ENVIRONMENTAL
IMPACT
REPORT

Addendum

Volume 2B: Response To Comments

1988
Revision
to
the
Air
Quality
Management
Plan

FIGURE II-2
Projected 24-hour peak PM10 concentrations

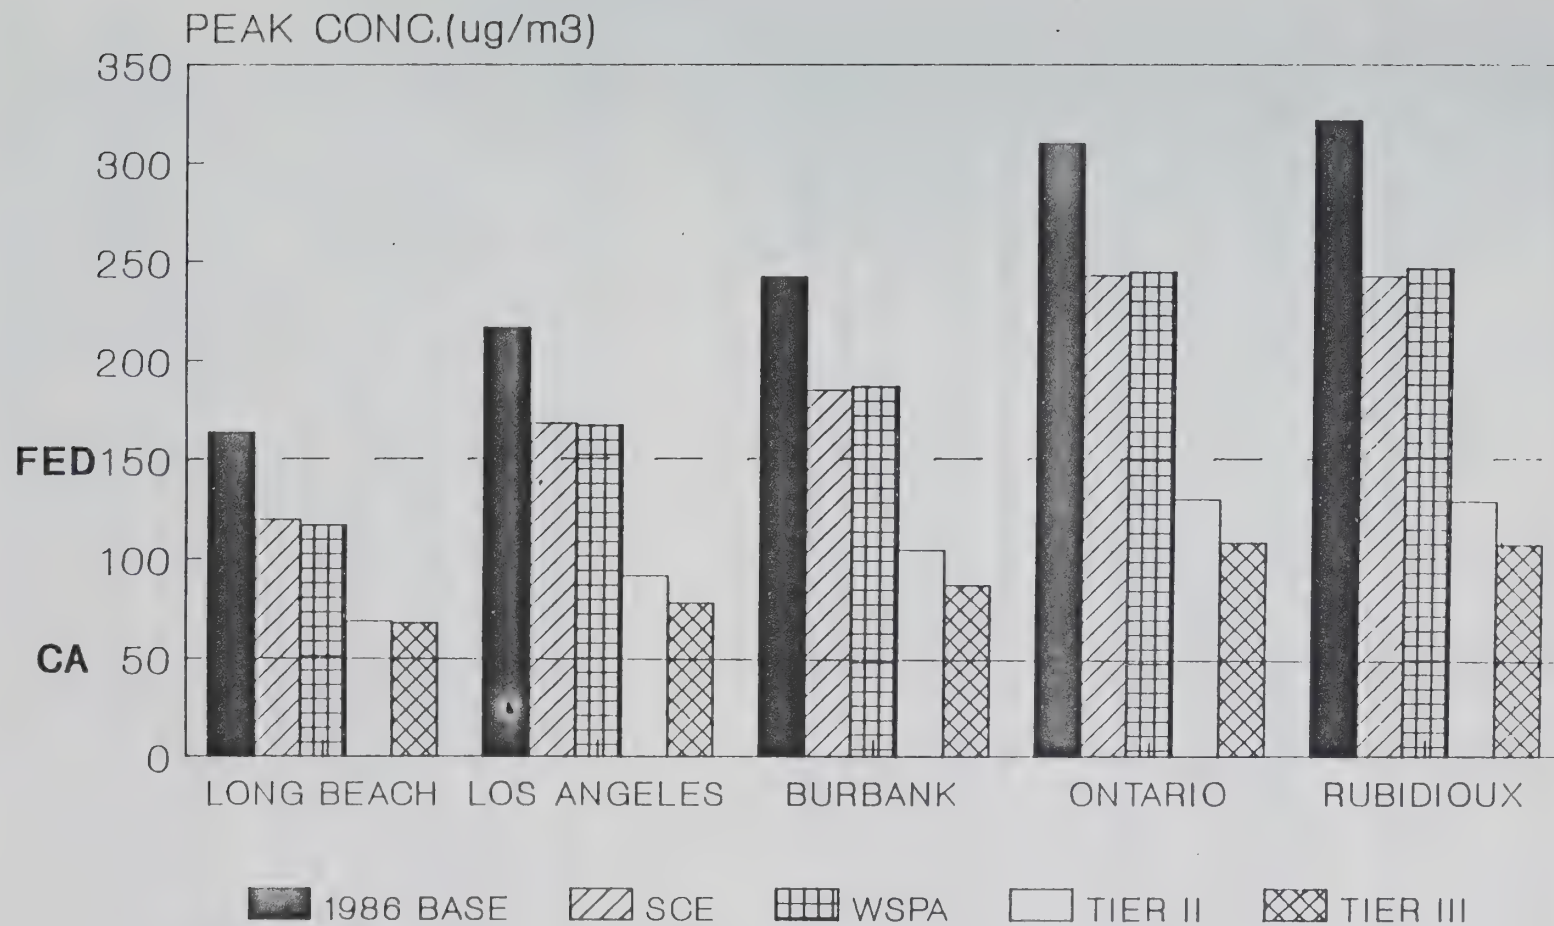
The reductions to 24-hour peak PM10 concentrations anticipated with these control strategies are shown in Figure II-2. At the analyzed locations, the alternative control strategies proposed by SCE and WSPA are expected to reduce 24-hour peak PM10 concentrations by about 21 to 29 percent of 1986 base case levels. The Tier II control plan will provide a 57 to 60 percent reduction, whereas Tier III reduces 24-hour peak PM10 concentrations between 64 and 67 percent of 1986 levels.

The SCE and WSPA alternative control plans are also predicted to fall short of the federal 24-hour PM10 standards at almost all locations in the Basin, as shown in Figure II-2. Tier II control will reduce peak 24-hour PM10 concentrations well below the federal standard of 150 $\mu\text{g}/\text{m}^3$ throughout the Basin. Tier III control is expected to produce PM10 concentrations which exceed the state short-term standard (50 $\mu\text{g}/\text{m}^3$) by a factor of about two, whereas the peak 24-hour PM10

FIGURE III-1
Model-Predicted Maximum Hourly Ozone Concentrations
in the South Coast Air Basin
Projected for 2010 Baseline

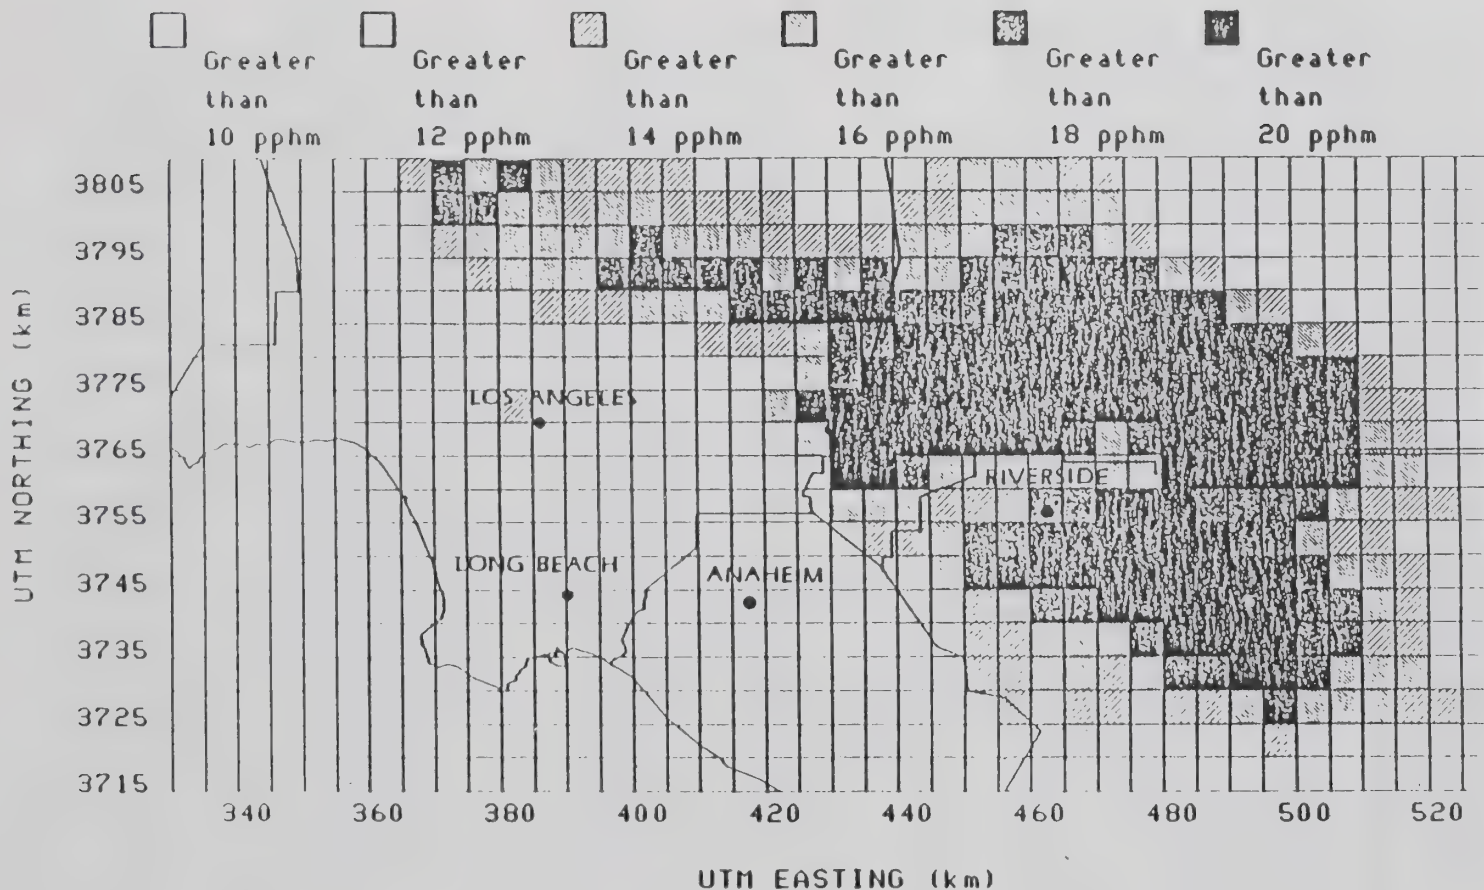
Figure III-1 shows the projected air quality for the 2010 Baseline scenario representing no implementation of any proposed AQMP measures. Ozone concentrations exceed the NAAQS throughout the San Gabriel Valley and the eastern portions of the Basin.

FIGURE III-2

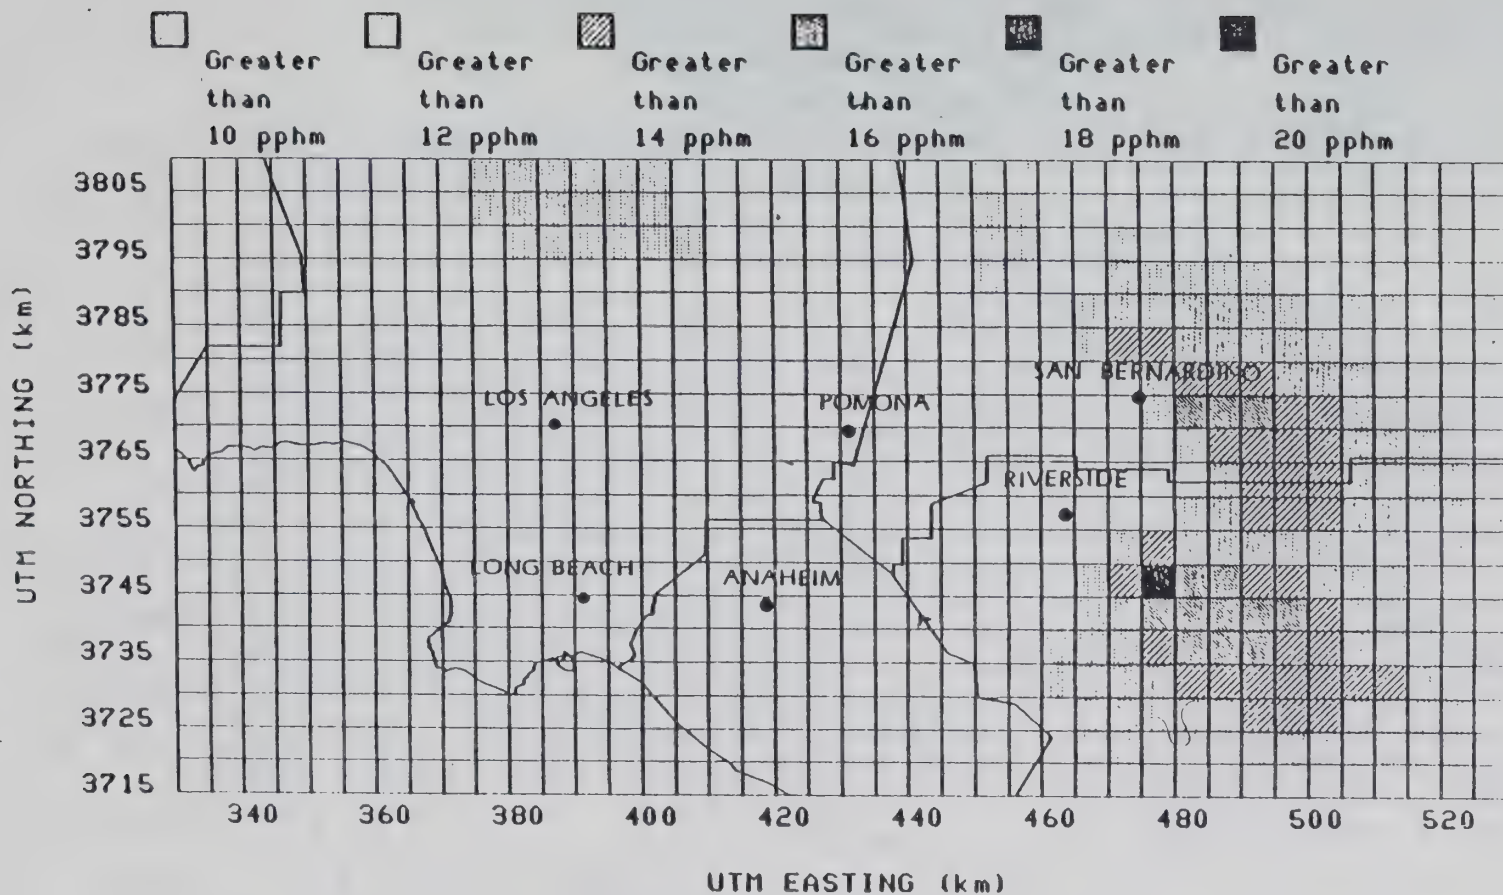
Figure III-2 shows the projected ozone air quality for the ROG-Only control scenario for the year 2010. Ozone concentrations exceed the NAAQS primarily in San Bernardino and Riverside Counties with the peak concentration exceeding 18 pphm in Riverside County.

FIGURE III-3

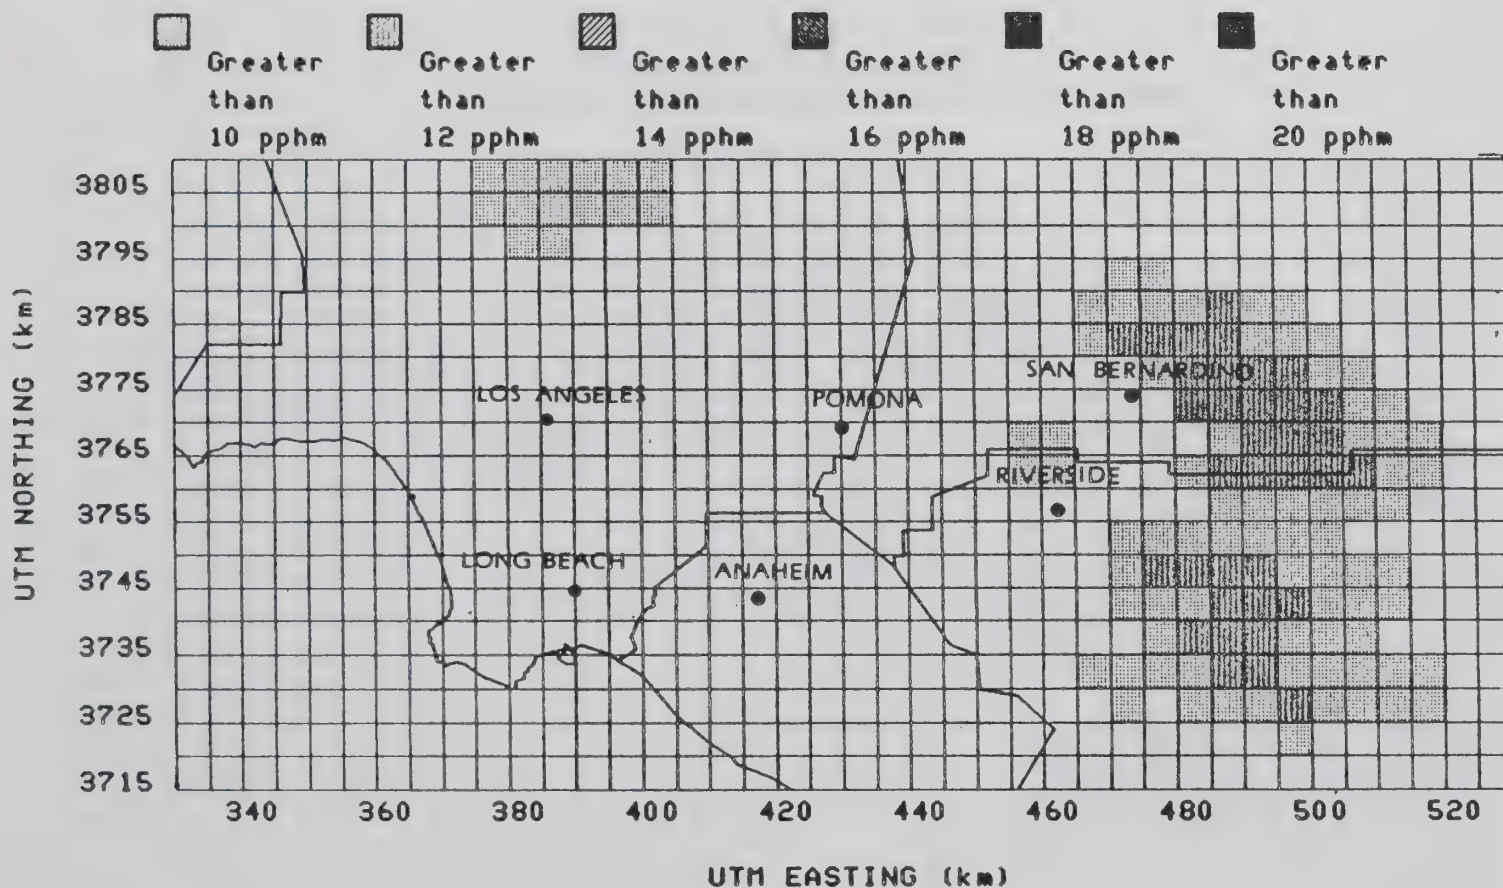
Figure III-3 shows the projected ozone air quality for the SCE Alternative scenario which includes mainly ROG measures and some high ROG/NO_x measures. The additional ROG reductions over the ROG only scenario result in lower peak ozone concentrations but the ozone level exceeds the NAAQS in parts of San Bernardino and Riverside Counties.

FIGURE III-4
 Model-Predicted Maximum Hourly Ozone Concentrations
 in the South Coast Air Basin
 for SCE Realistic Alternative Control Scenario

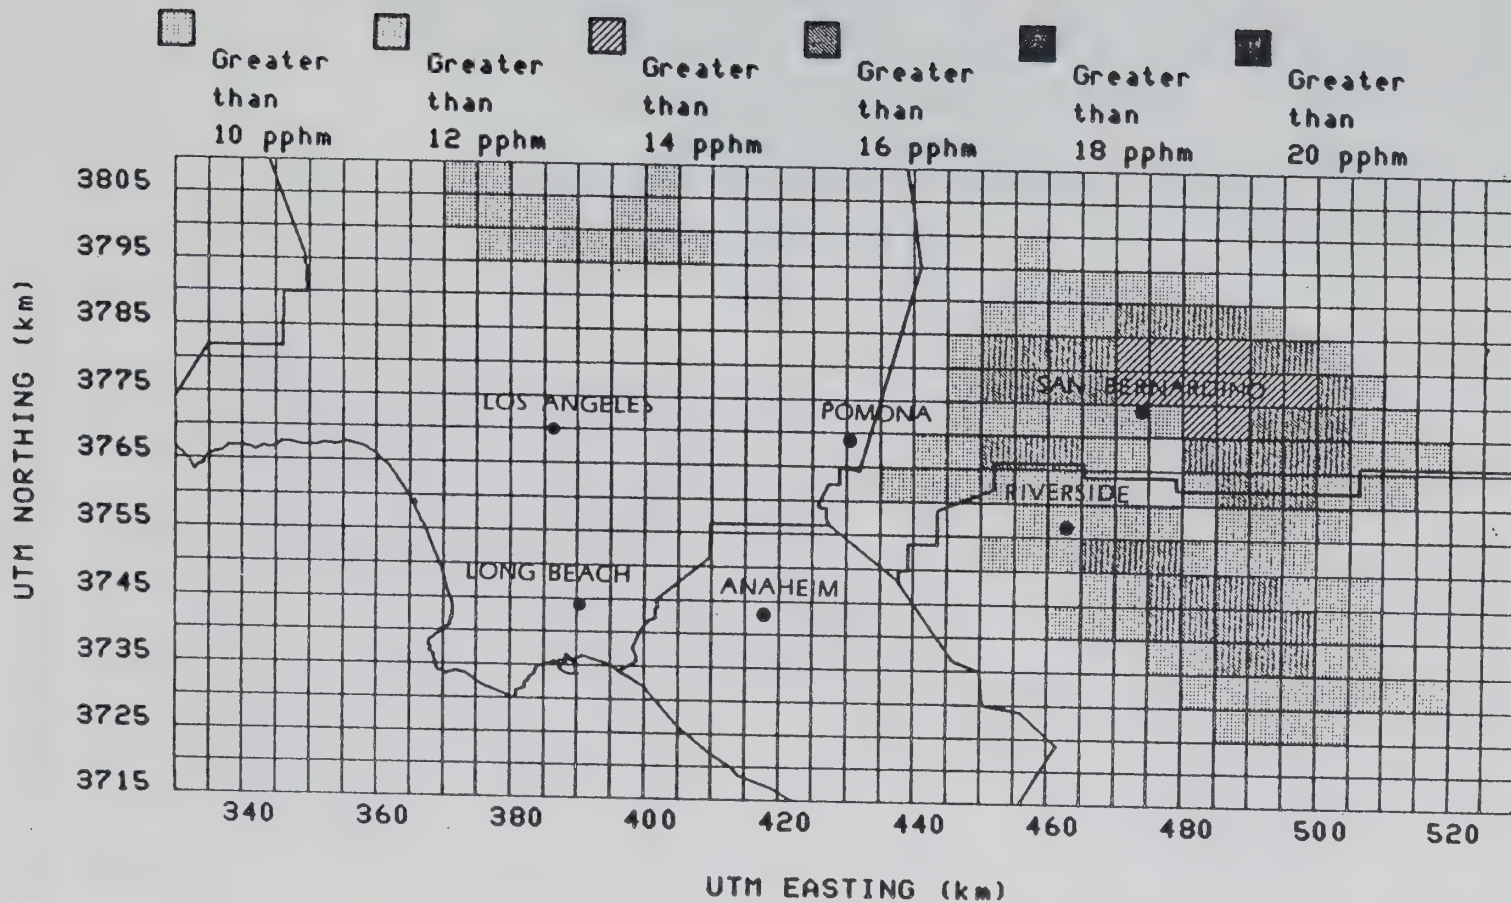
Figure III-4 shows the projected ozone air quality for the SCE Realistic Alternative scenario which is based on the SCE Alternative and including additional ARB and SCAG control measures which have already been adopted. The additional control measures result in a little more ROG reduction but significantly more NO_x reduction which produces peak ozone concentrations exceeding 15 pphm.

FIGURE III-5

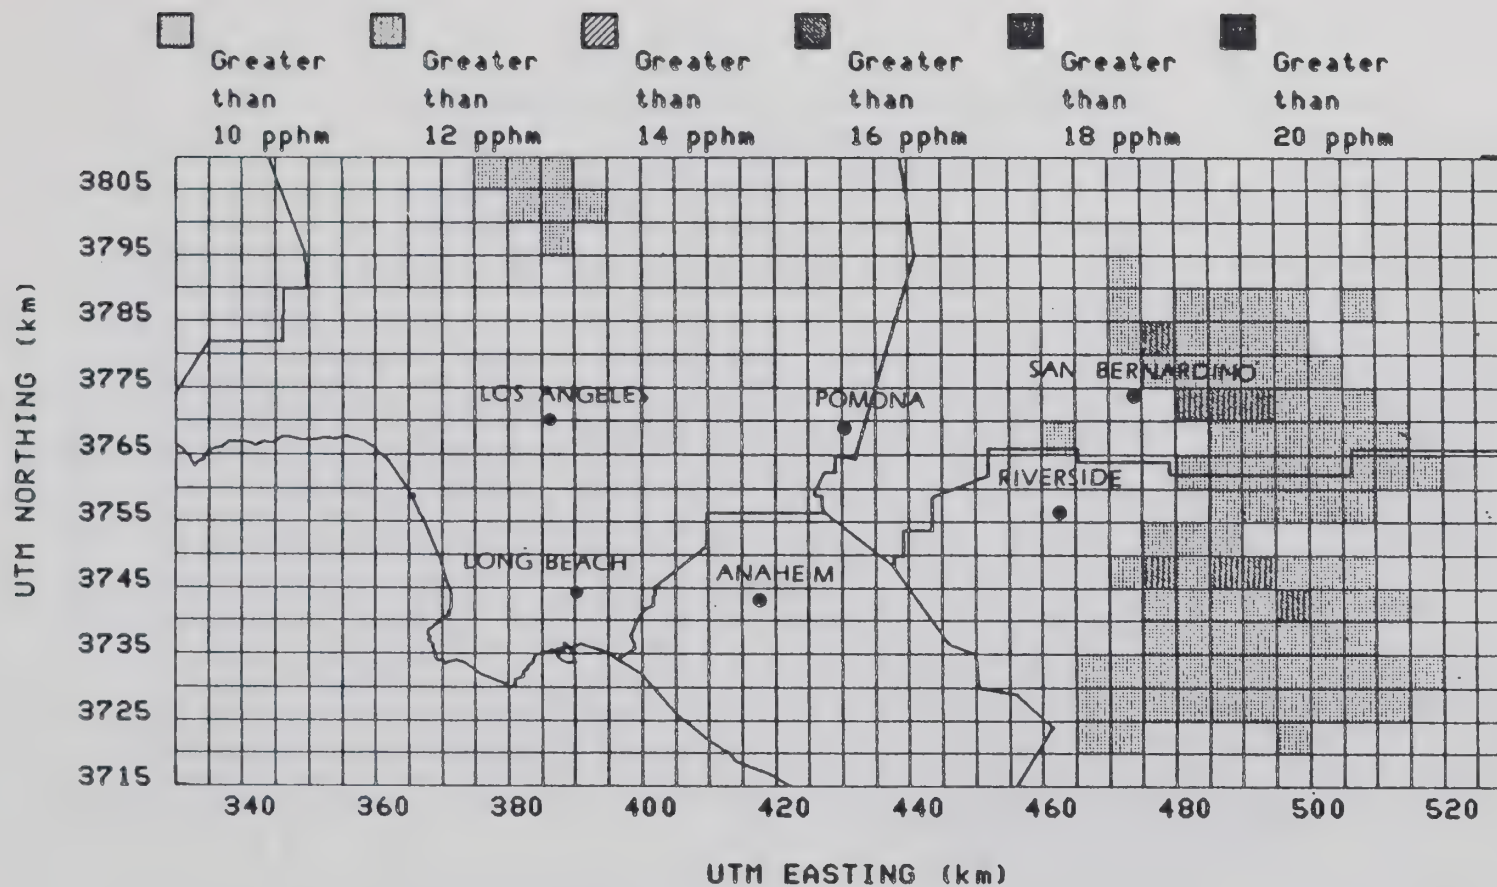
Figure III-5 shows the projected ozone air quality for the WSPA Alternative scenario, which like the SCE Alternative, includes mainly ROG measures and some high ROG/NO_x measures. The resulting ozone air quality is similar to the SCE Alternative shown in Figure III-3; the NAAQS is exceeded in parts of San Bernardino and Riverside Counties. Peak ozone concentrations are lower than the SCE Alternative because of the larger ROG reduction.

FIGURE III-6

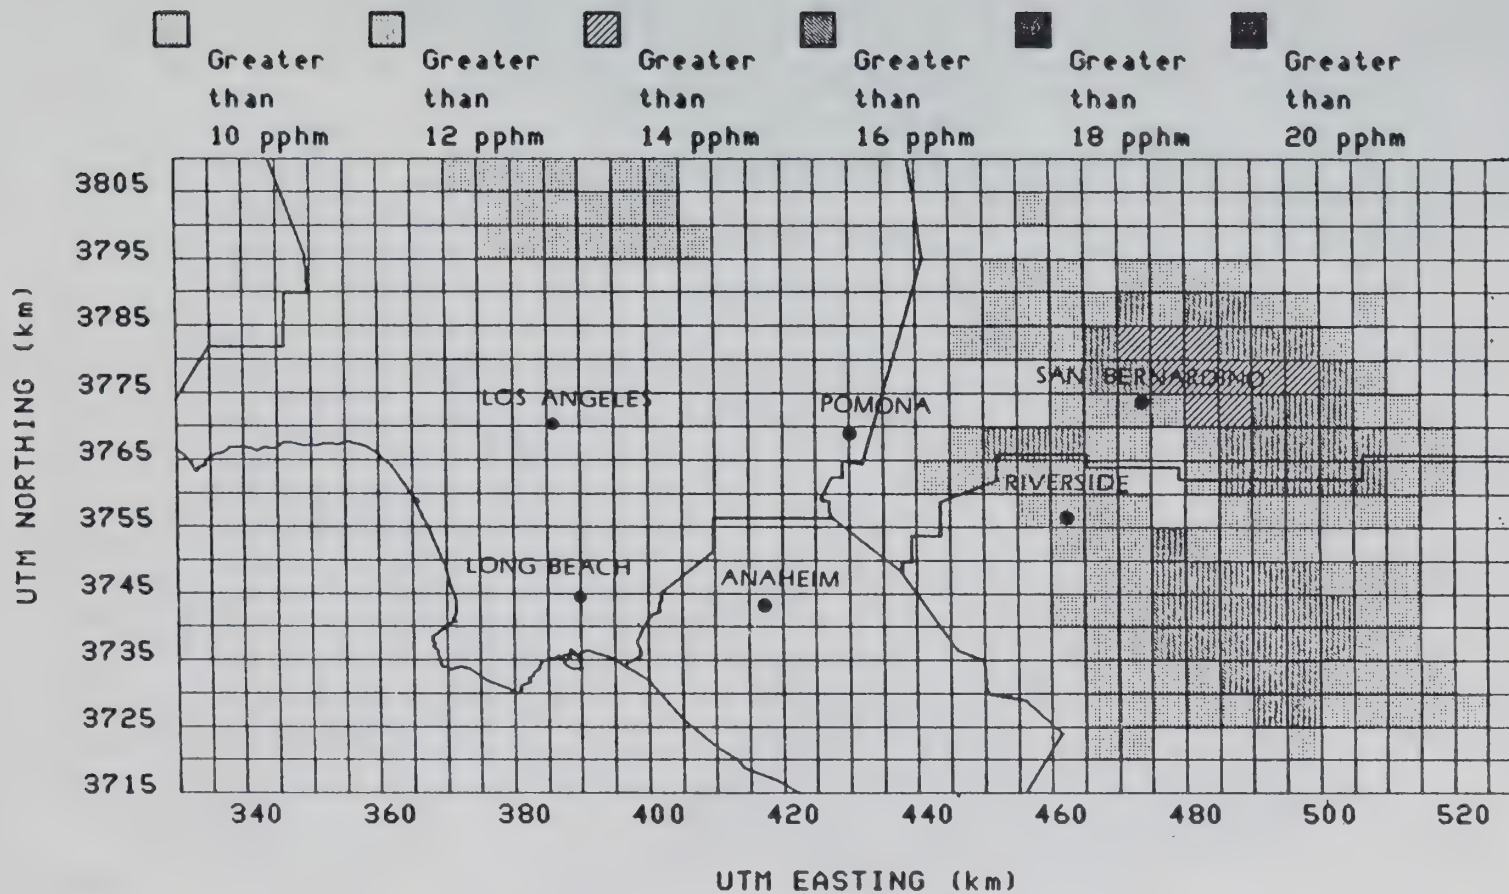
Figure III-6 shows the projected ozone air quality for the WSPA Realistic Alternative scenario which is based on the WSPA Alternative but only includes the ARB control measures which ARB staff consider feasible. Without as much ROG reduction, peak ozone concentrations are higher than the WSPA Alternative and violations of the NAAQS are more widespread.
